**CHARLOTTE DOUGLAS INTERNATIONAL AIRPORT  
CHARLOTTE, NORTH CAROLINA**

**ADDENDUM NO. 2**

**NORTH END AROUND TAXIWAY (NEAT)  
OVERLOOK RELOCATION**

**CLT PROJECT NO. AVIA 23-50  
ADDENDUM DATE: MAY 25, 2023**

SHT. LE-1

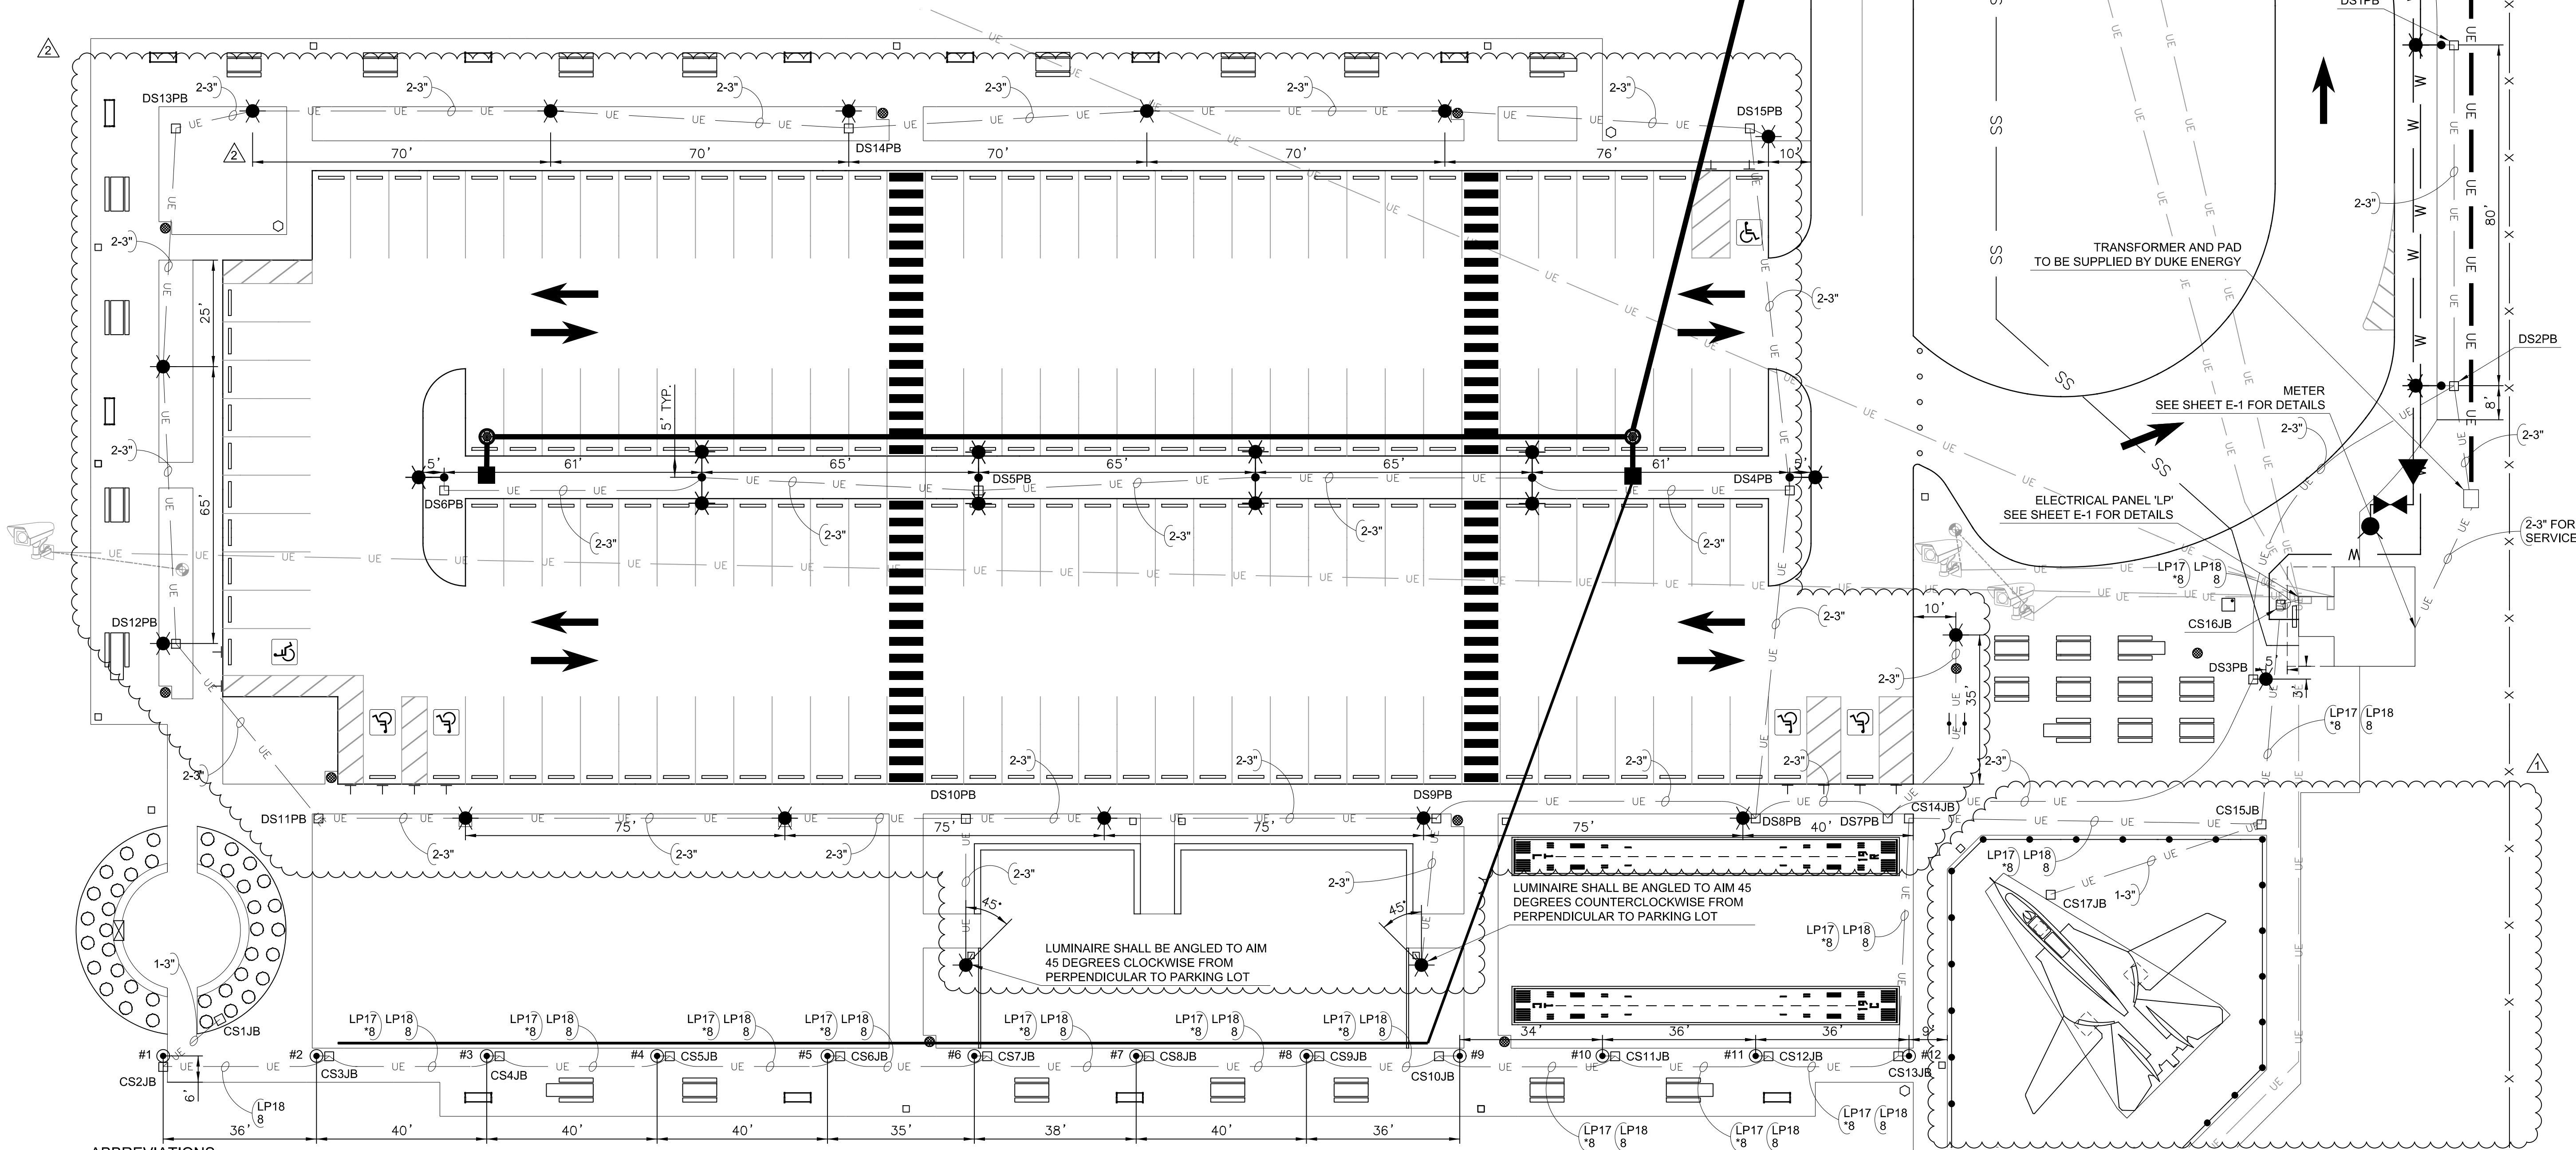
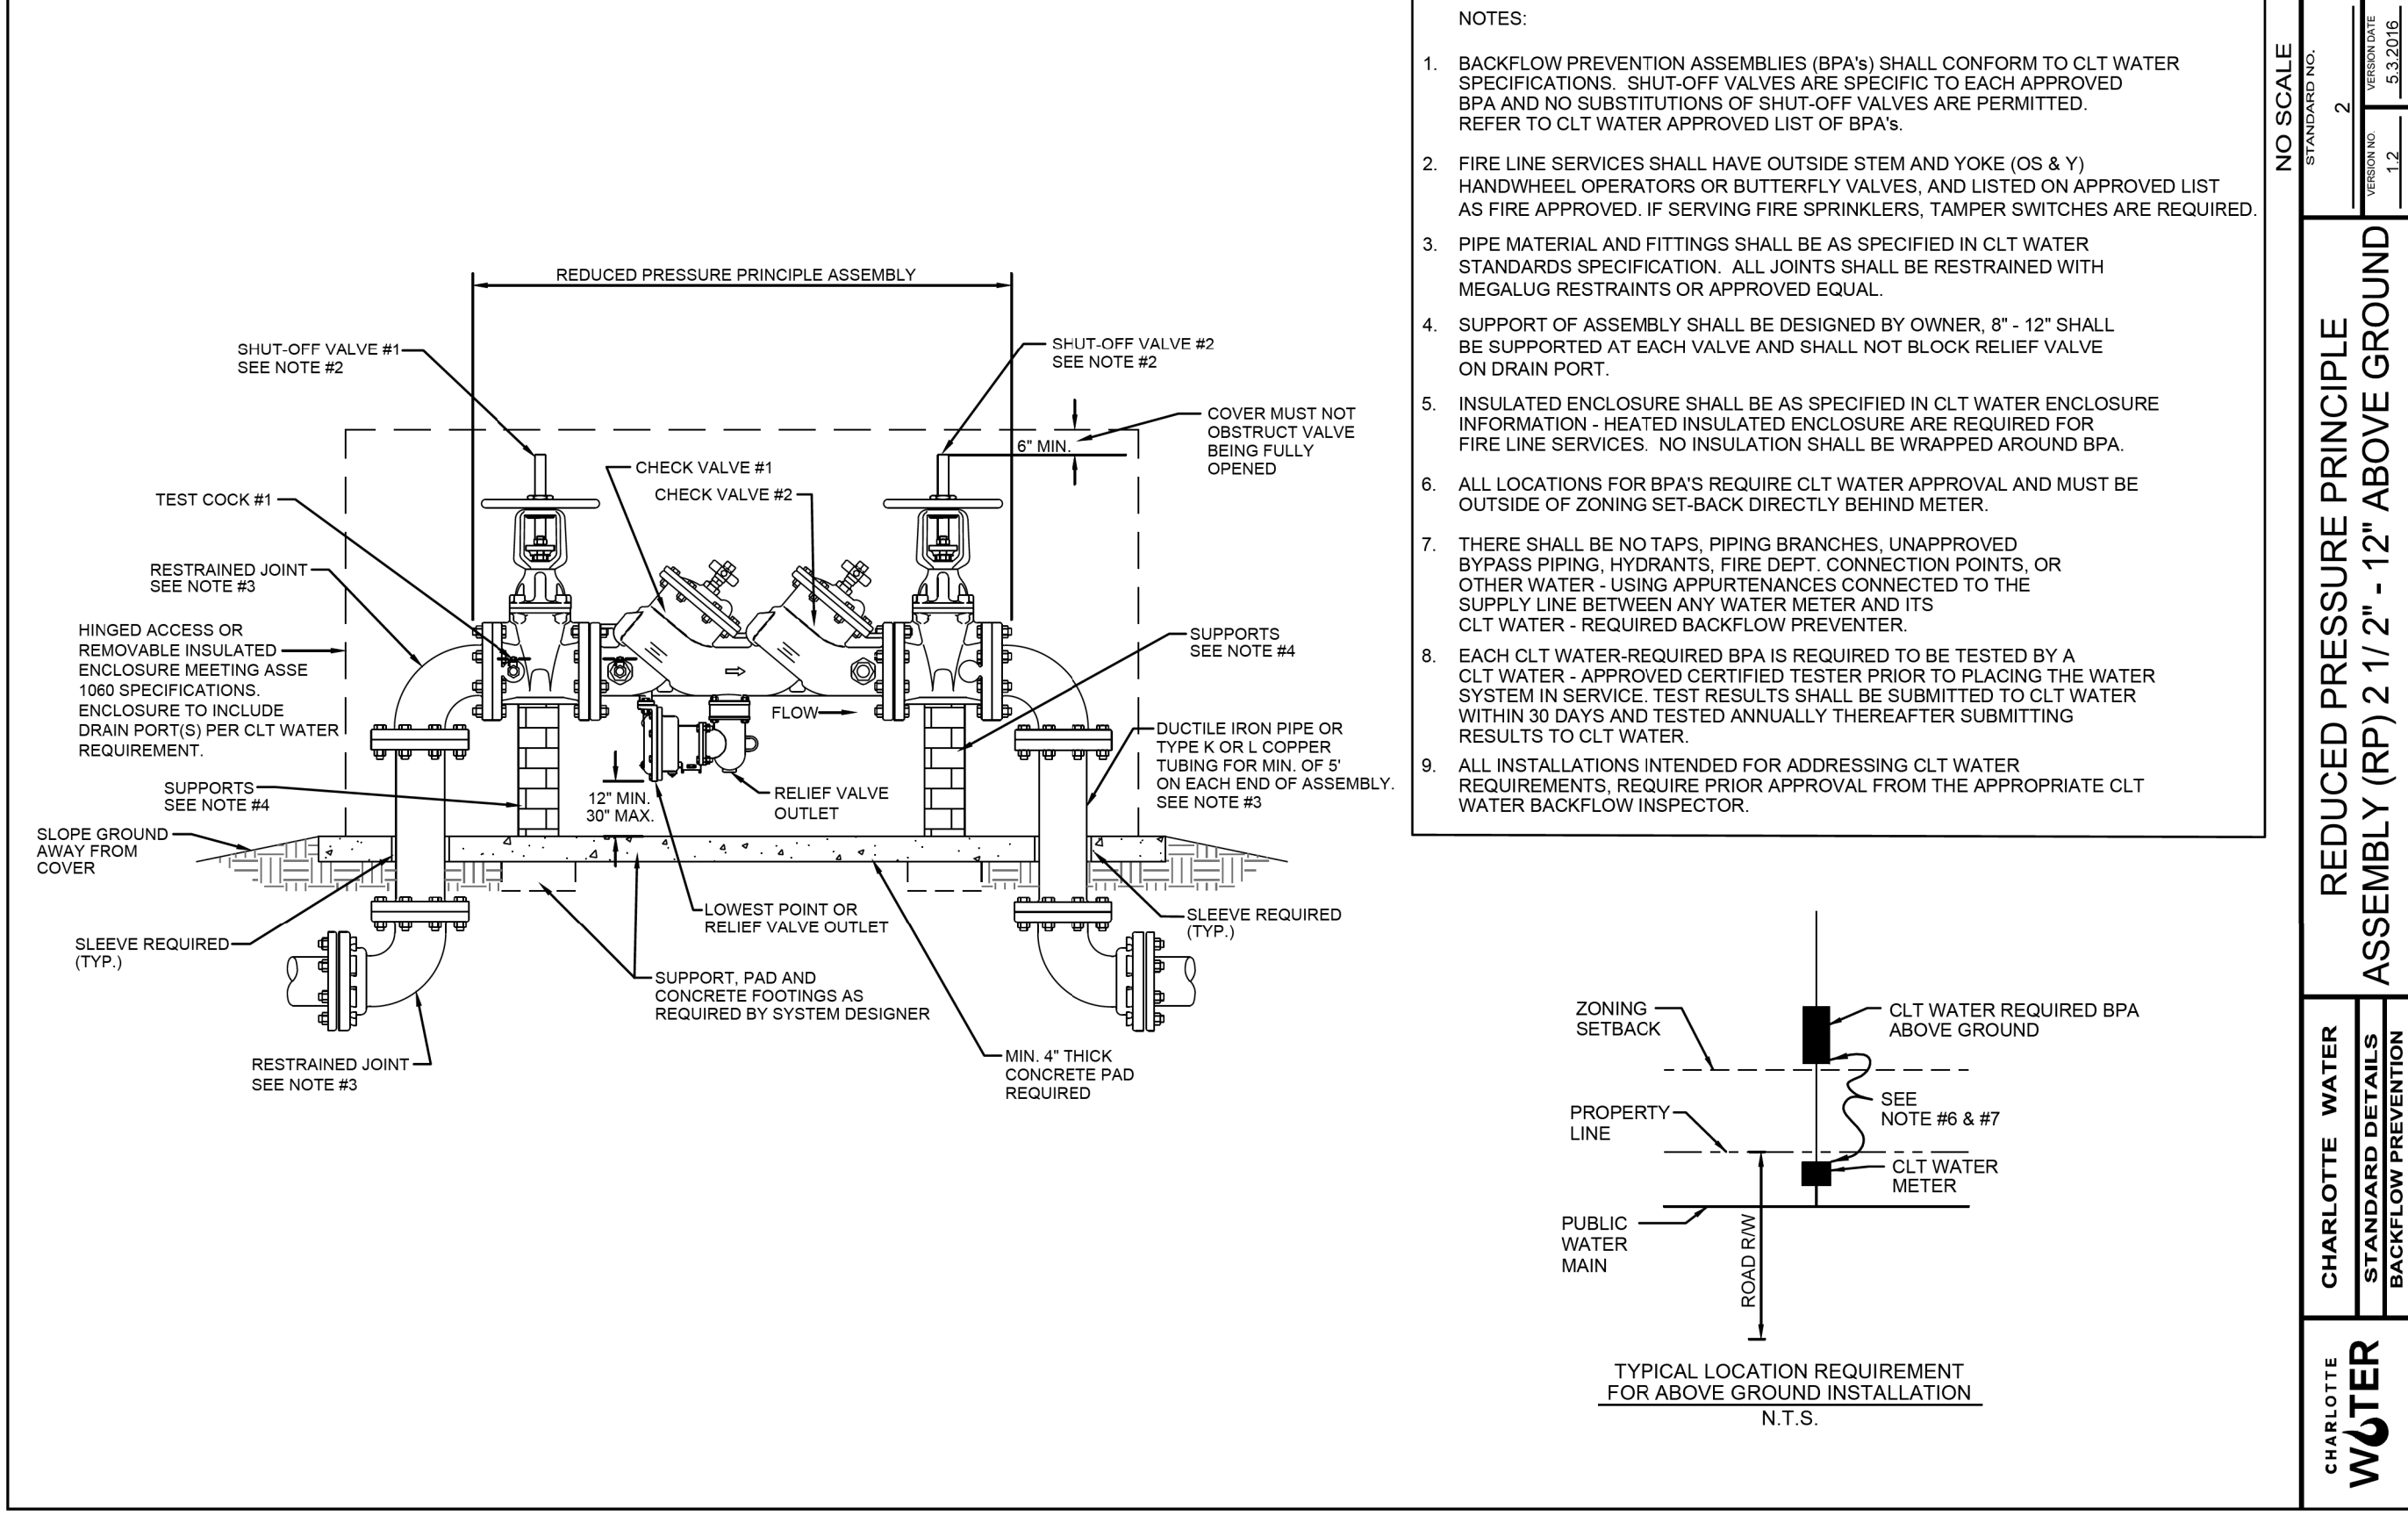
REVISIONS		DATE
1	ADDENDUM NO. 1 - REVISED AIRCRAFT DISPLAY AREA	05/15/2023
2	ADDENDUM NO. 2 - REVISED DUKE SUPPLIED PULLBOX DESIGN	05/25/2023
3		
4		
5

- NOTES:
- ALL LIGHT POLES/BOLLARDS ARE OFFSET 1' FROM EDGE OF NEAREST SIDEWALK UNLESS OTHERWISE NOTED.
  - BOLLARD LIGHTS SHALL BE TIED FROM ELECTRICAL PANEL TO PHOTOCELL FOR DUSK TO DAWN CONTROL. (SEE SHEET E-1 FOR DETAILS)
  - ALL ROADWAY/PEDESTRIAN LIGHT POLES SHALL HAVE 1-3" CONDUIT FROM LIGHT POLE TO NEAREST ELECTRICAL PULLBOX/JUNCTION BOX.
  - BOLLARD LIGHTS SHALL BE INSTALLED ON A CONCRETE BASE WITHIN THE SIDEWALK. (SEE SHEET 3A-9 FOR DETAIL)
  - CONTRACTOR SHALL INSTALL ALL DUKE SUPPLIED PULLBOXES. COORDINATE WITH YTULO EVANS 803-835-7945 TWO (2) WEEKS IN ADVANCE FOR DELIVERY OF PULLBOXES.
